Hydrothermal Modeling of Browns Ferry Nuclear Plant With Units 1, 2, and 3 at Extended Power Uprate

WR2005-1-67-135

Prepared by
Paul N. Hopping
and
Walter L. Harper

Knoxville, Tennessee
February 2005

Figure 11. Computed and Measured River Temperature Upstream of BFN for 1993

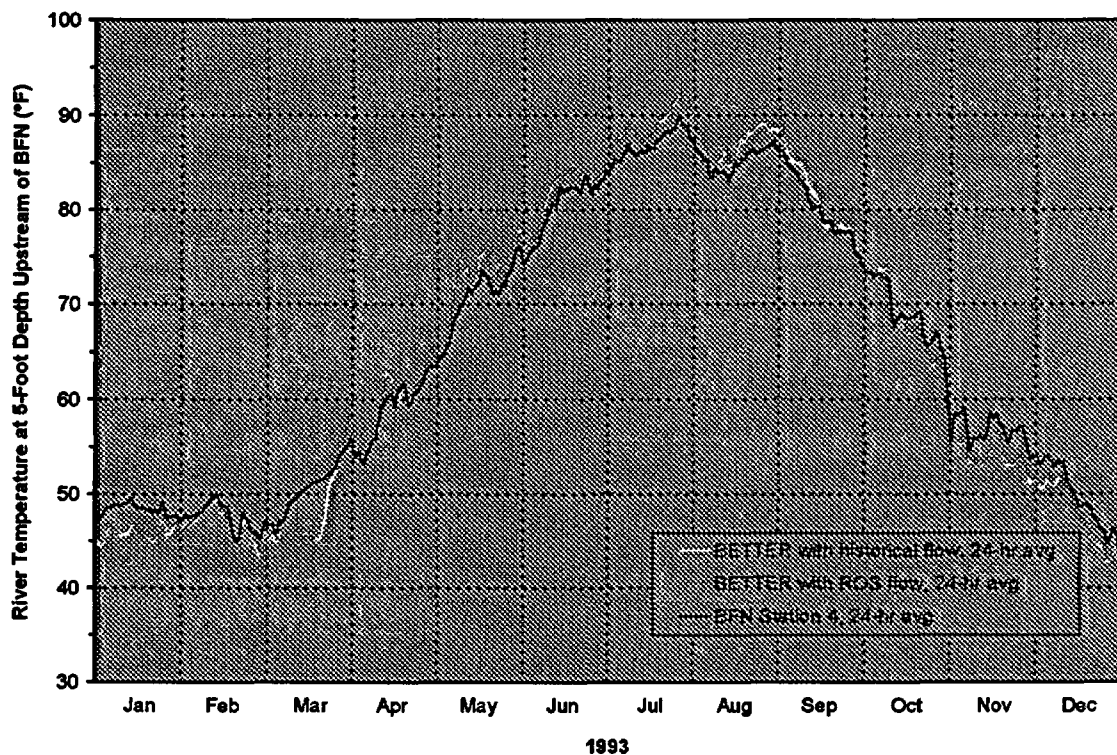
II.3.2 The response to Question 11, regarding Figure 11 and the effects of ROS releases on upstream river temperatures at the hourly scale, should be included in the report.

Figure 23. Computed vs. Measured Temperatures for Two-Unit Operation for Summer 2002

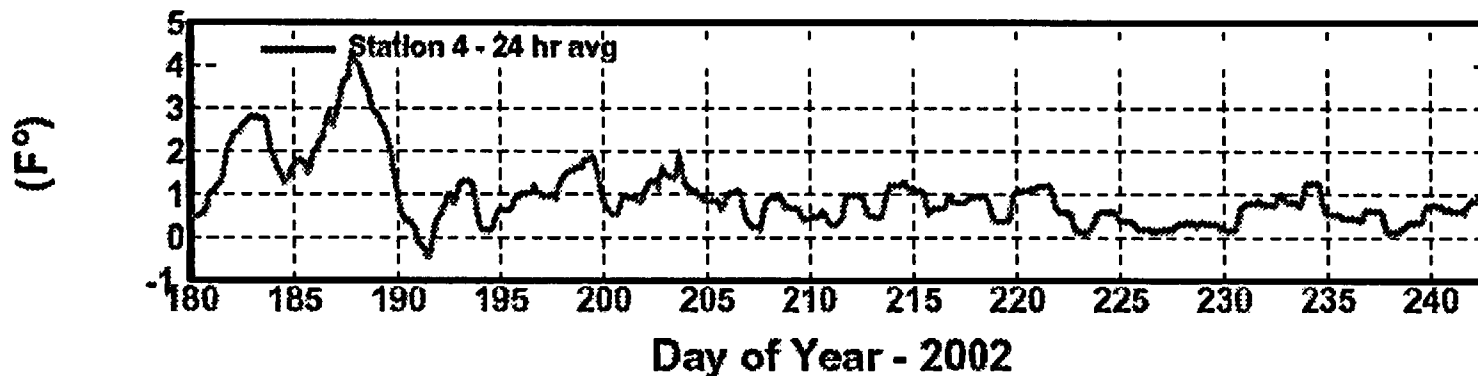
II.1.3 The rather poor agreement between the measured and computed downstream temperatures from days 206 to 218 in 2002, Figure 23, should be commented on in the text. Something else must have been going on.

Figure 25. Baseline (Case 0) Results for BFN Simulations

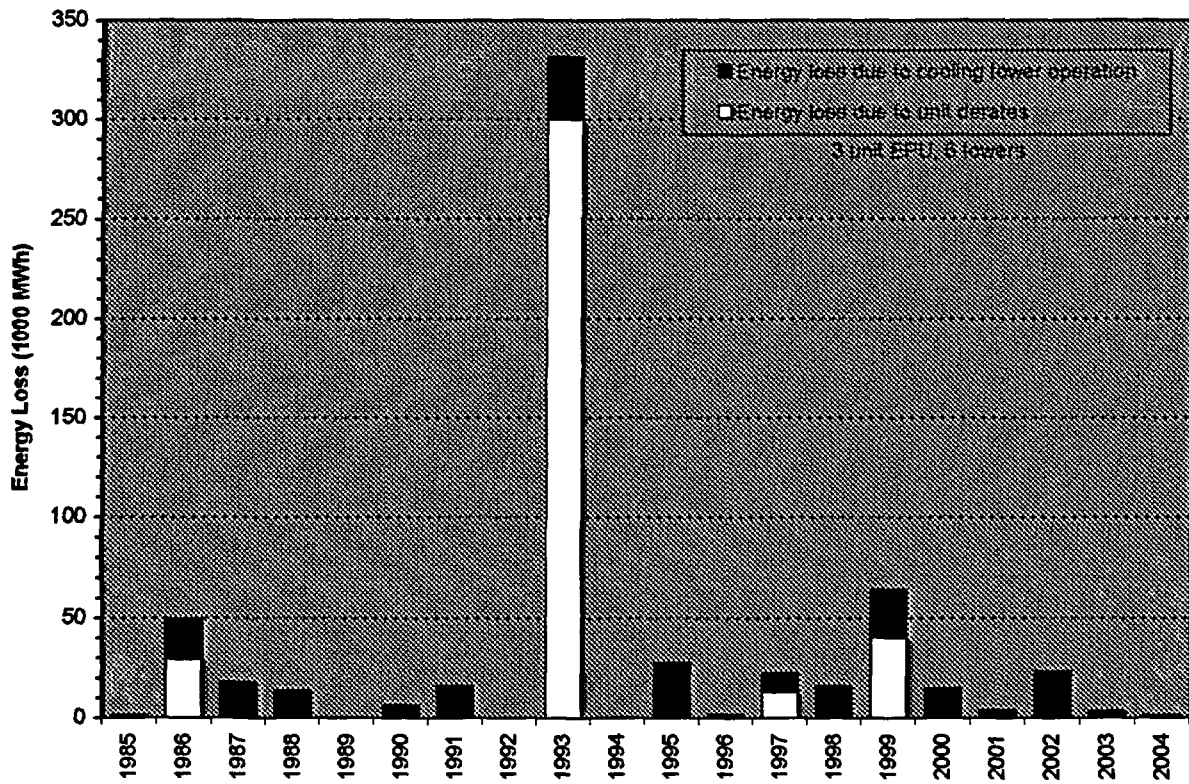
II.7.1 The Case 0 results as depicted in Figure 25 are not consistent with Table 9 from which they were drawn. However these same results as depicted in Figures 31, 32, and 33 appear to be correct.

Figure 26. BFN Operation for 1993

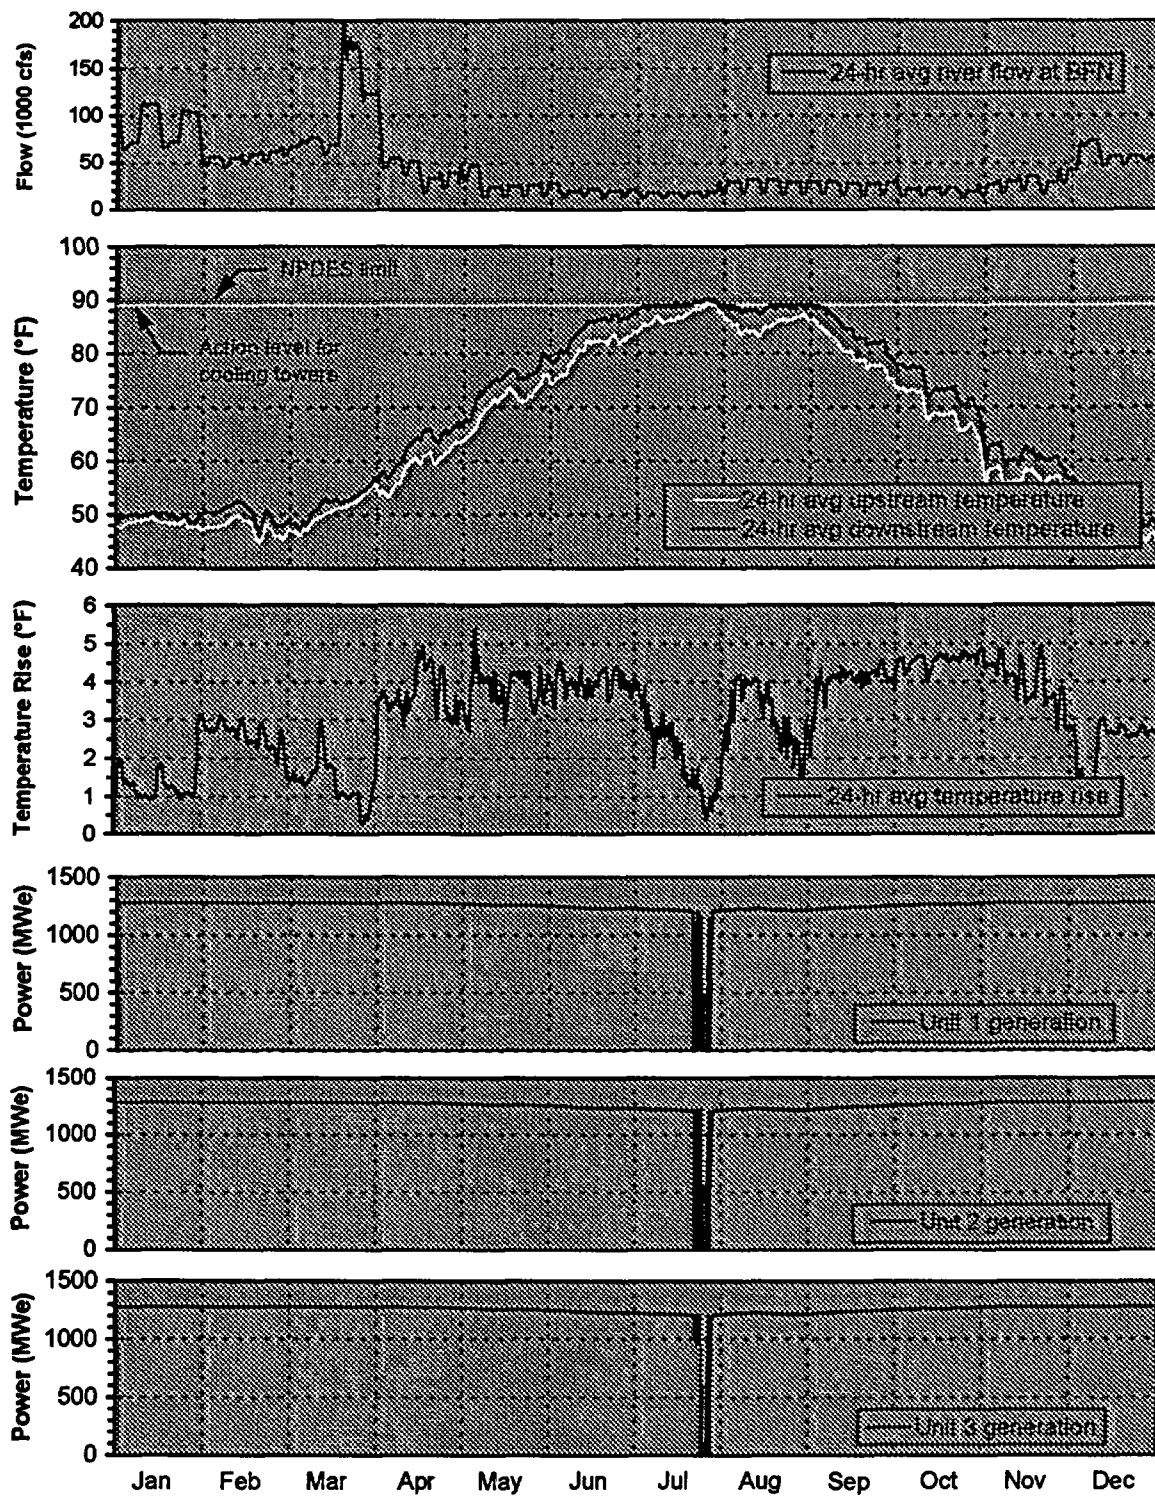
II.7.2 In Figures 26 and 27, one can infer when towers were in operation by the changes in the temperature rise. Nonetheless, it would be interesting to show tower operation directly, as the text refers to the timing of tower operation as well as unit derates. This would add one panel to the Figures, but it would make the Figures even more complete and informative.

Figure 27. BFN Operation for Late July 1993

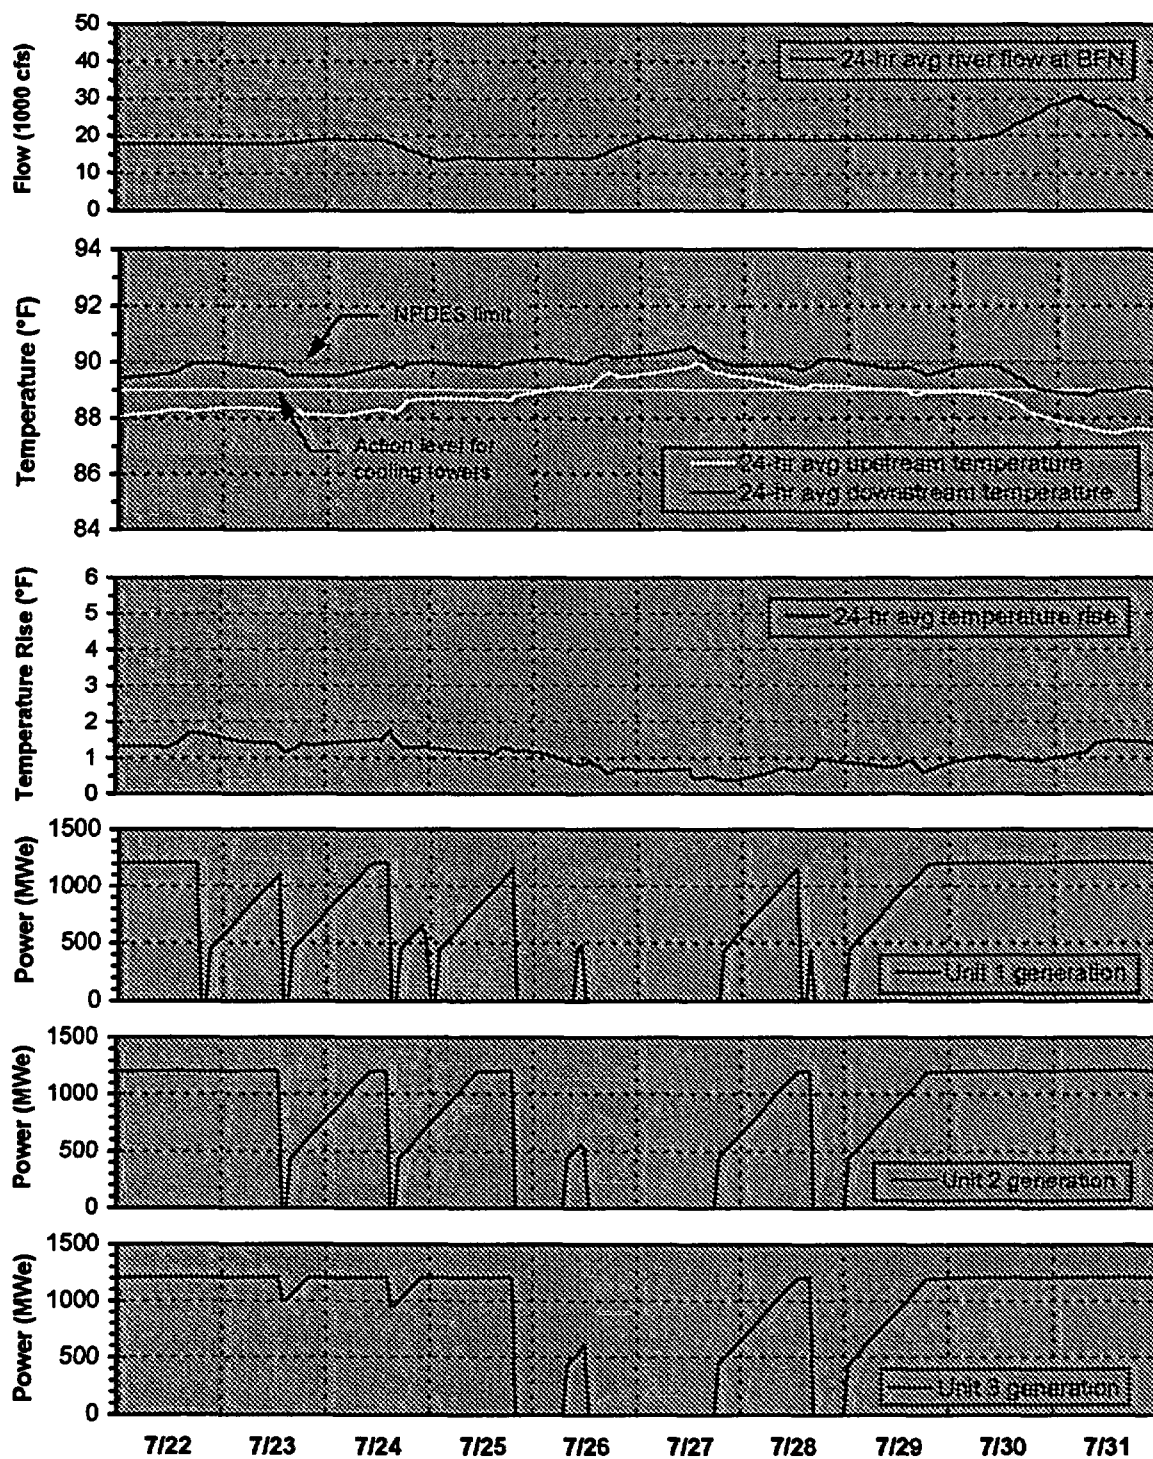
II.1.5 Figure 27 seems to suggest that the model predicted an apparent NPDES permit violation on 26-27 July of 1993 – yet in the model the units were shut down. There is

Figure 29. Effect of Condenser Cleanliness Factor on Condenser Temperature Rise

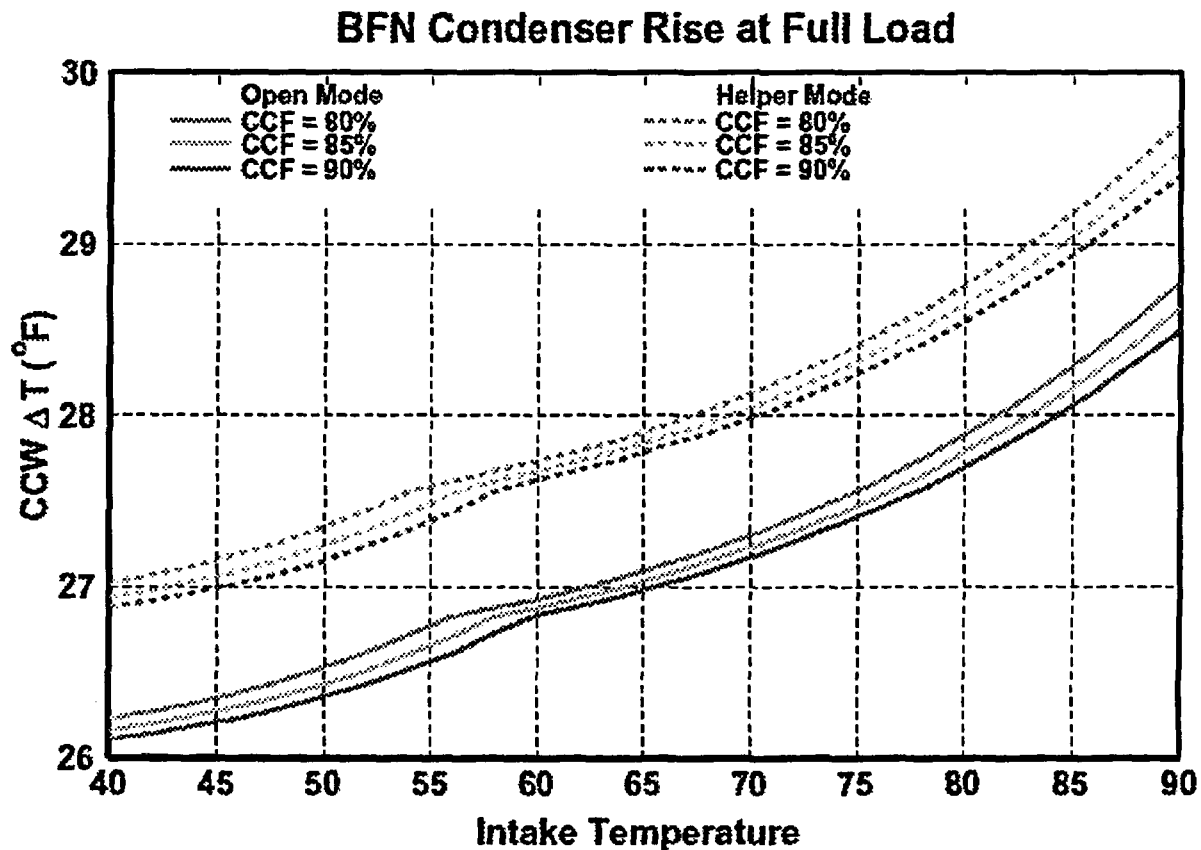
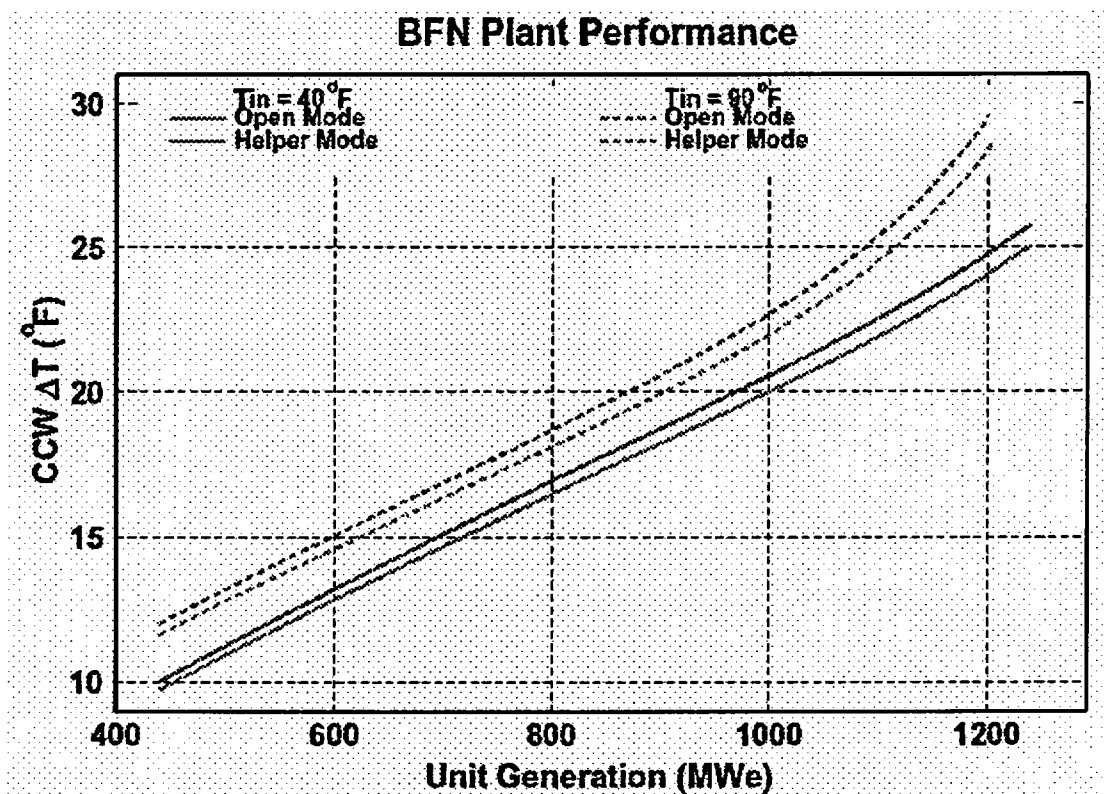
II.3.1 Figure 29 has some strange kinks in the condenser curves that do not appear to be reflected in Figure 16. These are not the same presentation, but it would be helpful if the authors could explain the anomalies in the curves, if in fact they are anomalies.

16. Page 30, Figure 16. Does the higher CCW ΔT for helper mode simply reflect the reduced CCW flowrate, or am I missing something else?

The reduction in CCW flow is due to the increased losses associated with passing the water through the conduits to the cooling tower warm water channel (e.g., see Figure 5 and Figure 6). This brings to the attention another feature of the model that needs to be better emphasized in the report—that is, the hydrothermal model does not determine the detailed hydraulic characteristics of the flow throughout the CCW conduits and channels (e.g., HGL and EGL).
